# Bradley Heights Apartments

## A 236-Unit Apartment Development Puyallup, Washington

### Bradley Heights SS LLC

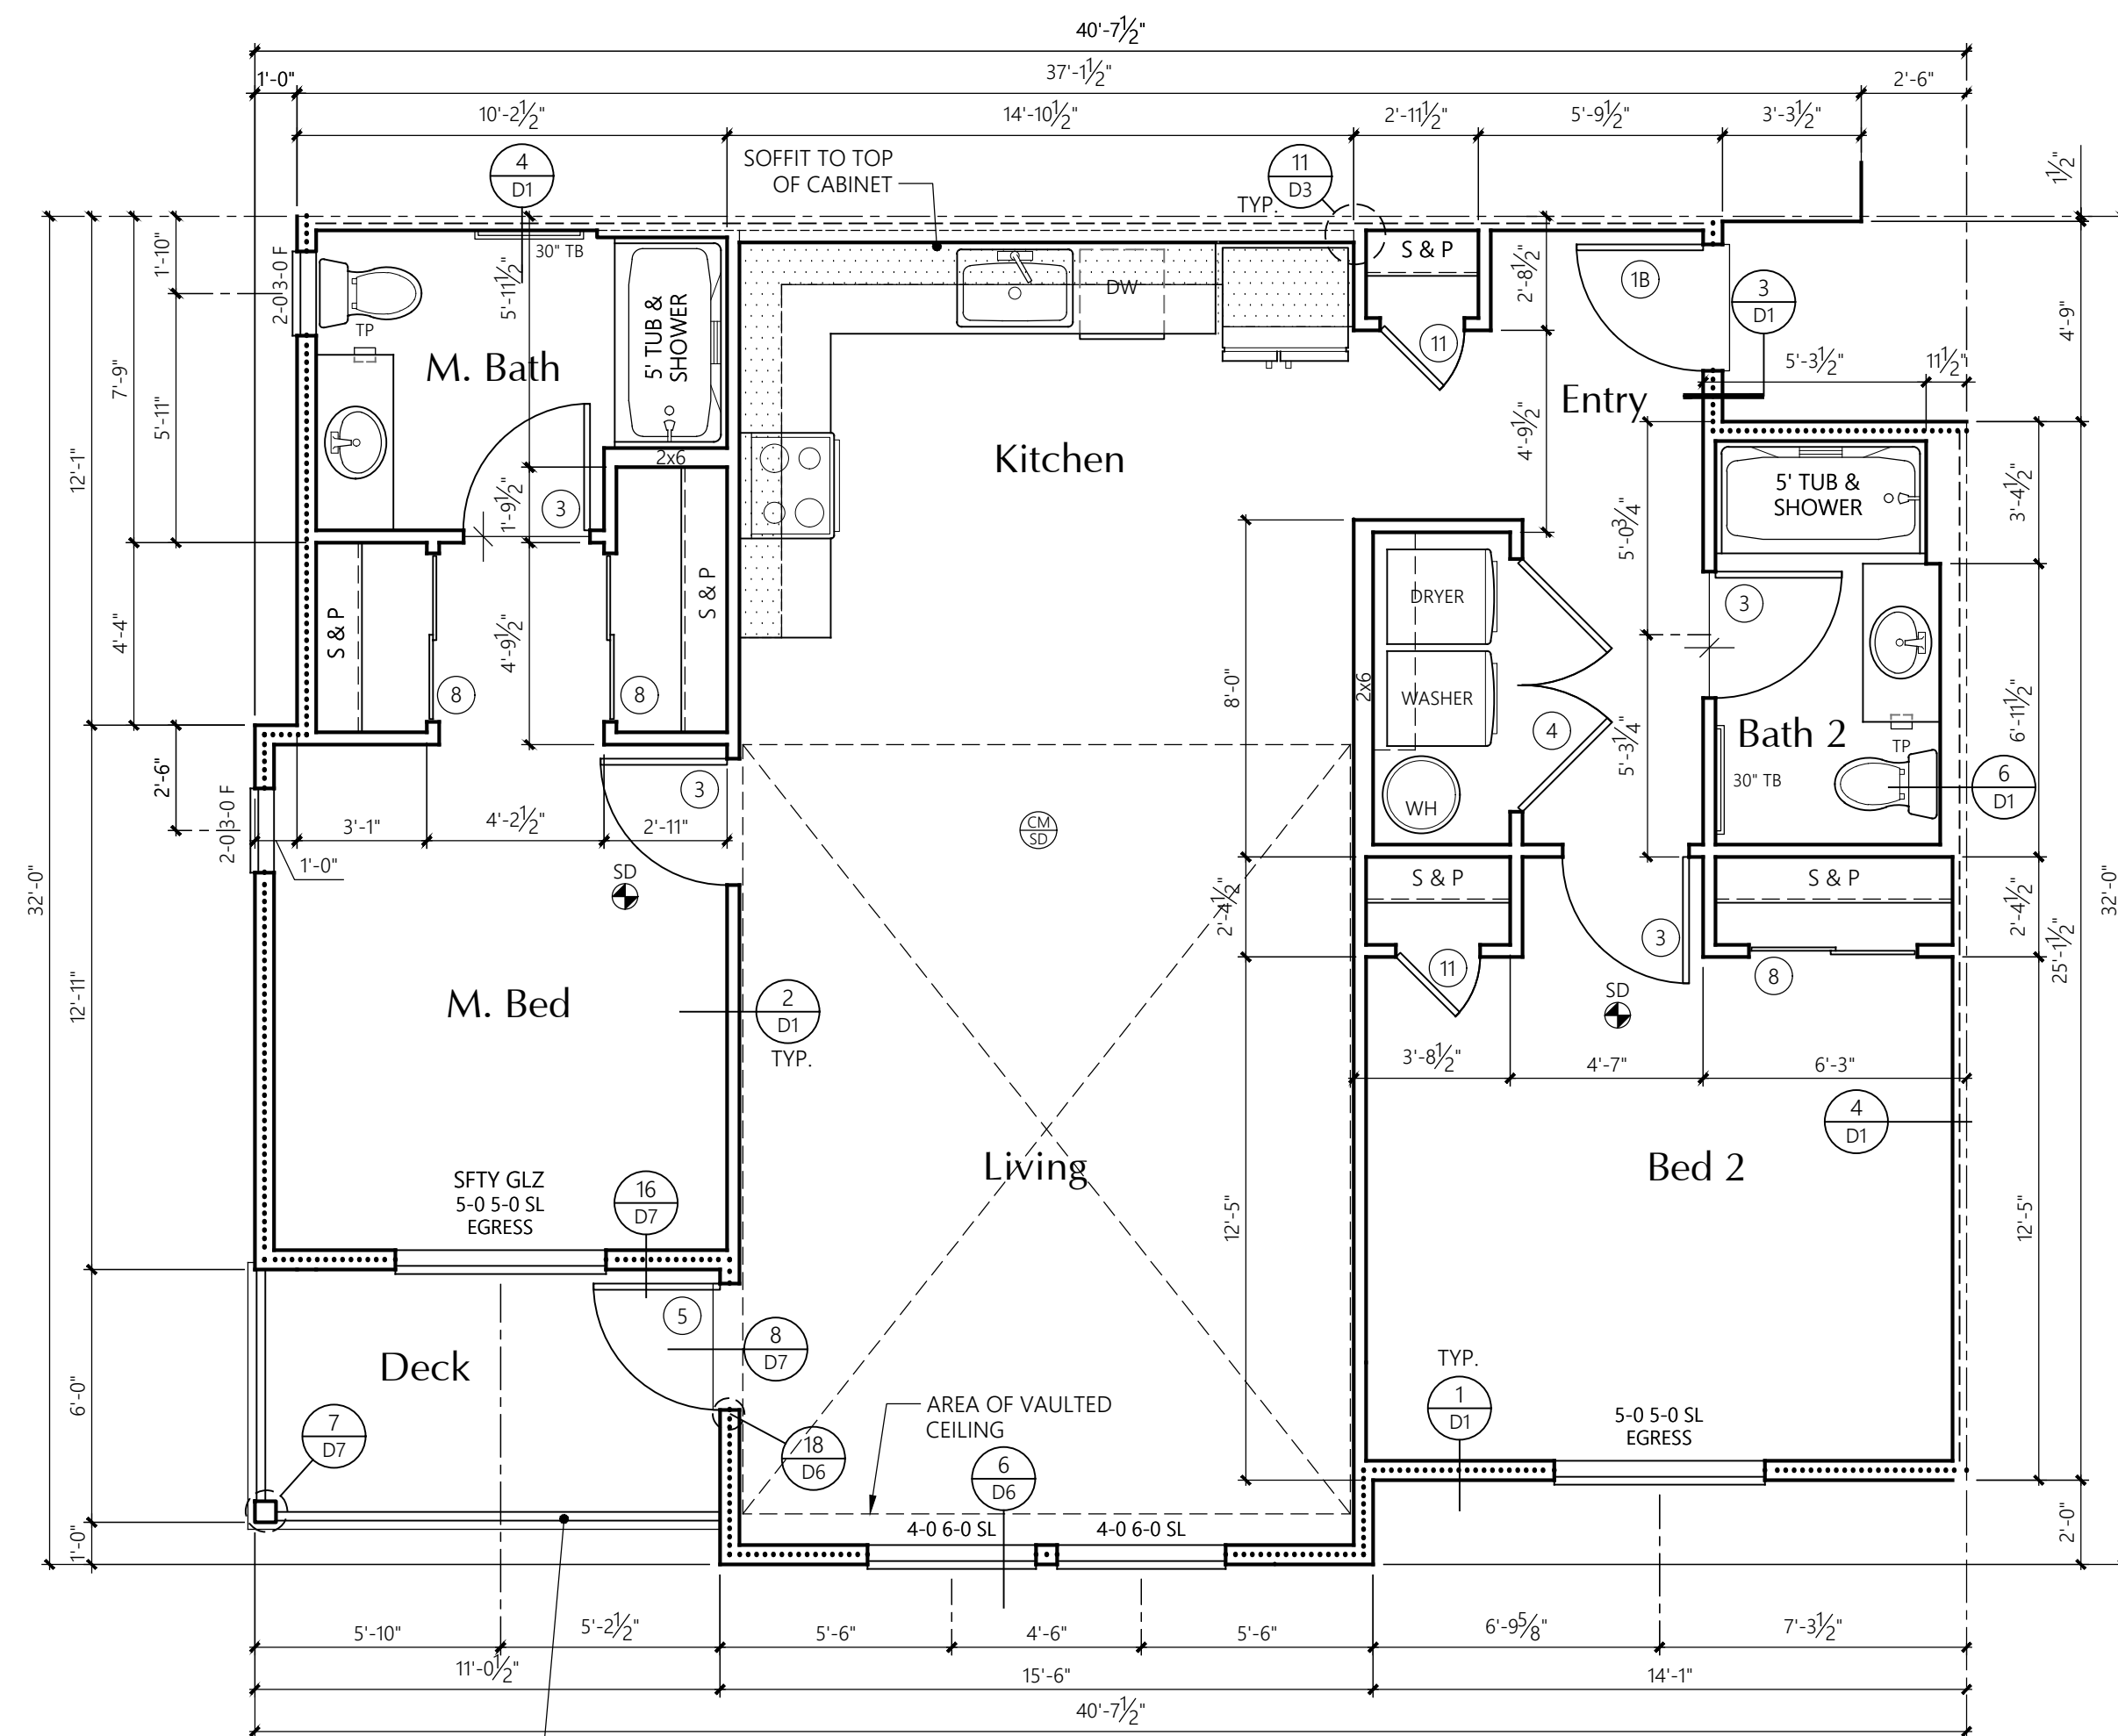
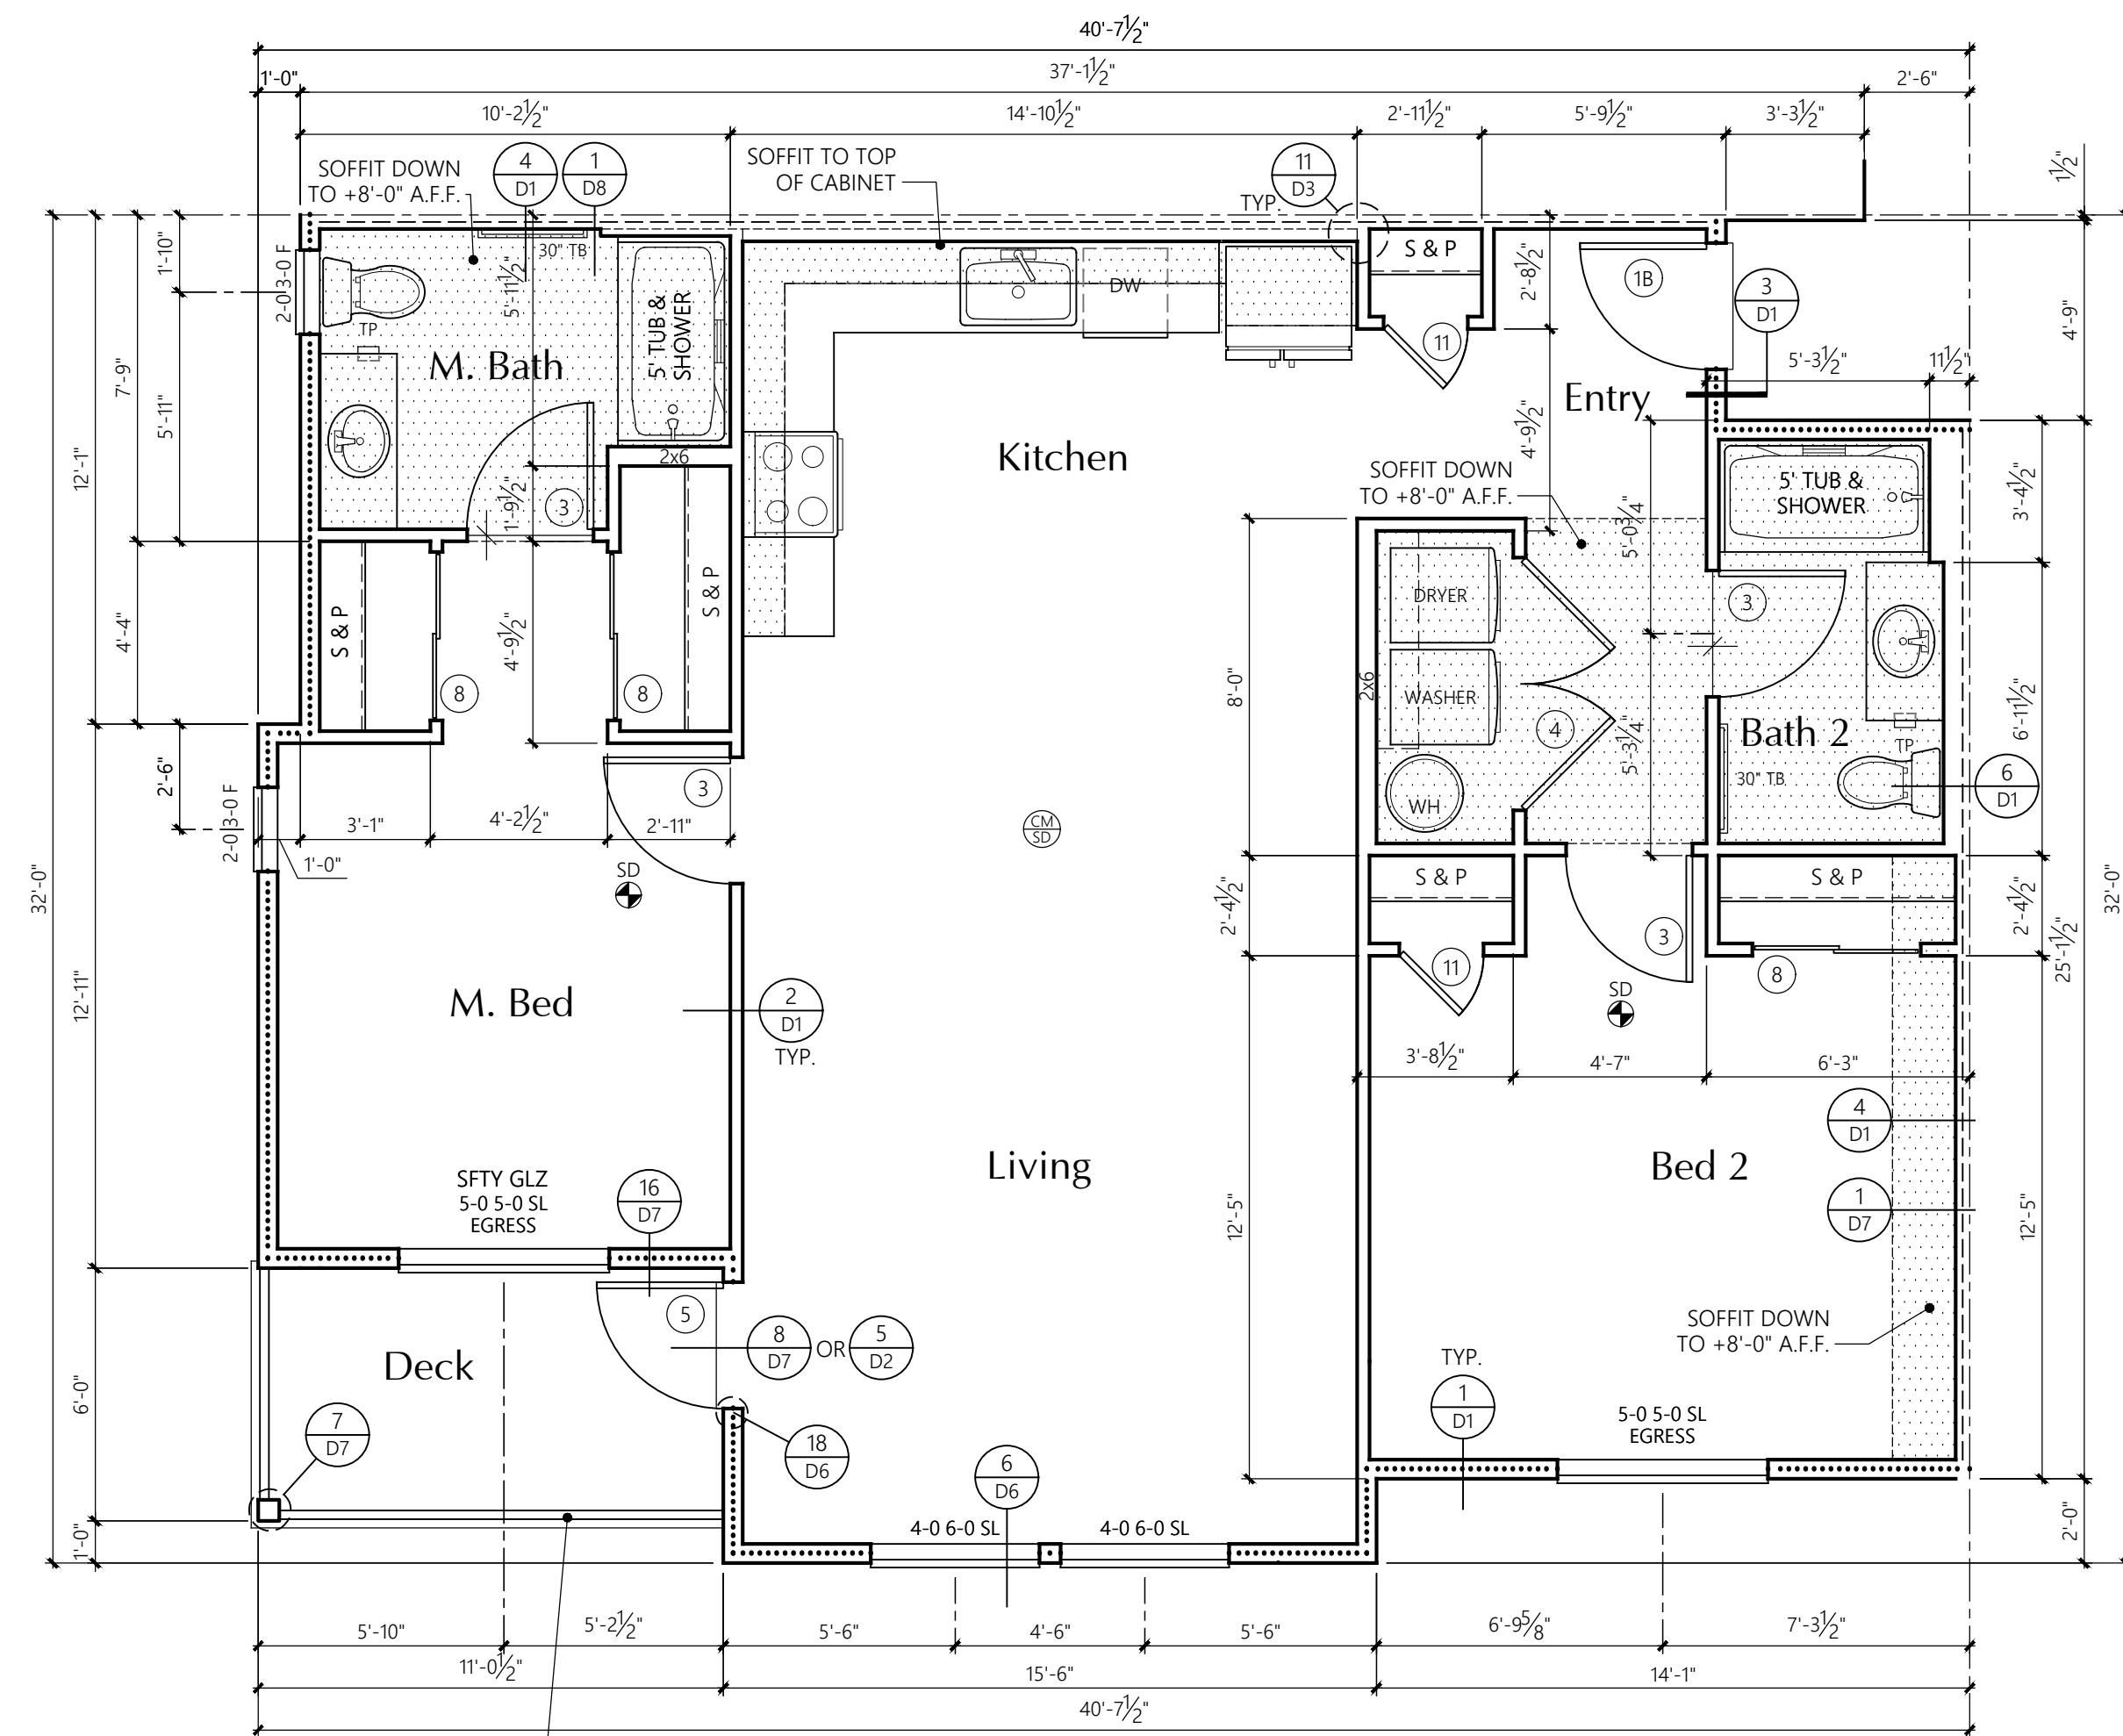
Review locations of smoke detectors and carbon monoxide detectors to insure they are placed per Washington State Building Code, Section 907.2.10.2 and 915.2.1. See Sheet U5.1 outside Bed 2 as an example only. Review all unit layouts for other instances.  
(Construction Set, Sheet U1-U5.1, Unit Plans)

**BUILDING F** FRONT ELEVATION  
1/8" = 1'-0" WINDOW HDR HEIGHT 8'-0" A.F.F. UNO

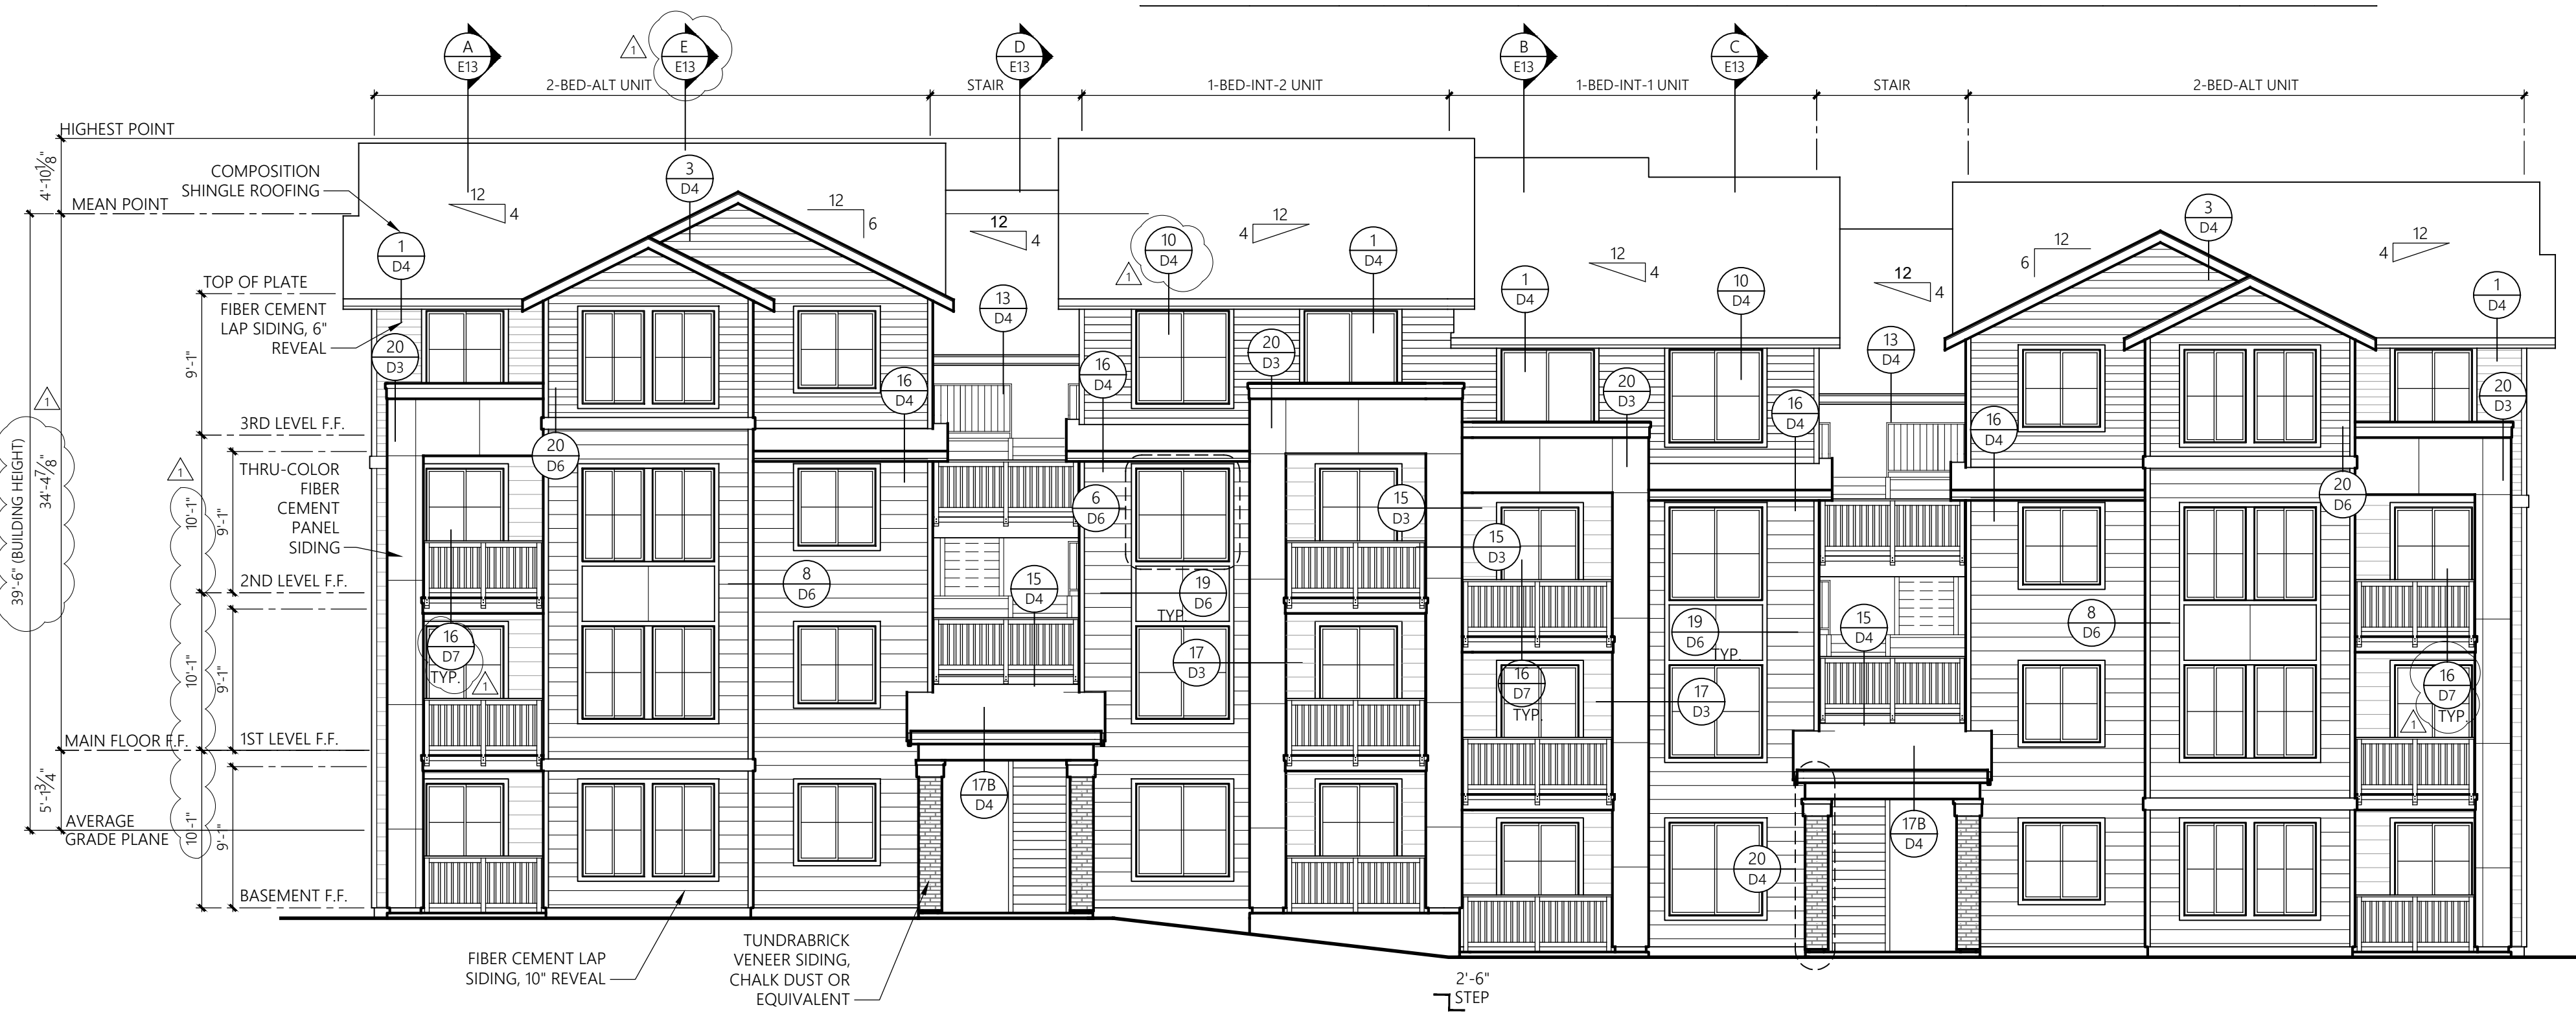
Provide average grade plan calculations, use a more detailed calculation to accommodate the more complex slope and irregular shape of the structure.  
(Construction Set, Sheet E12, Building Elevations)
